Comments on 10GBASE-T Draft 3.1

**IEEE P802.3an Task Force
Denver, March 7-9, 2006**

Gottfried Ungerboeck

Comment #47: equation (55-4), etc.

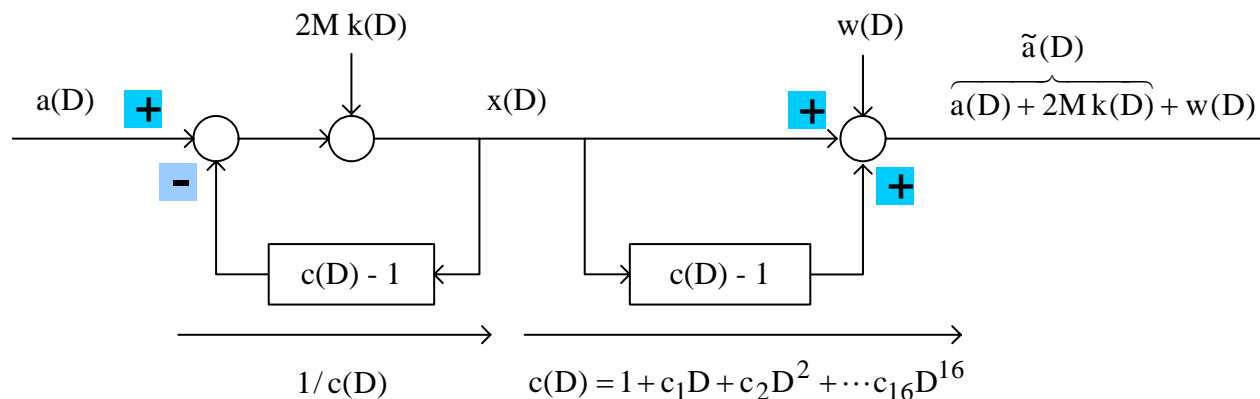
- 55.4.3.1, page 124, line 46: TR

C: The sign preceding the summation in equation (55-4) ~~is wrong~~ disagrees with THP literature and is unnatural. ---- For TH precoding the overall channel from the precoder output to the output of the adaptive feedforward equalizer in the receiver is equalized towards a causal monic response $c(D) = 1 + c_1D + c_2D^2 + c_3D^3 + \dots$. The TH precoder prefilters the sequence of transmit symbols $a(D)$ by $1/c(D)$ and adds to each symbol an integer multiple of $2M$ such that the precoder output lies in the interval $[-M, +M]$, where $M = 16$ in the case of 10GBASE-T. Writing the precoder output as $b(D) = a(D) + 2M \cdot m(D) - [c(D) - 1] \cdot b(D)$ corresponds to $b(D) = [a(D) + 2M \cdot m(D)] / c(D)$, where $m(D)$ is a sequence of integers.

R: Hence, the sign preceding the summation in equation (55-4) should be minus (-). ---- Suggested further notational changes: use ~~'b'~~ \tilde{a} for the augmented symbols 'a + 32*m', and 'x' for the precoder output; then in equation (55-6) replace 'a sub agmt' by ~~'b'~~ \tilde{a}
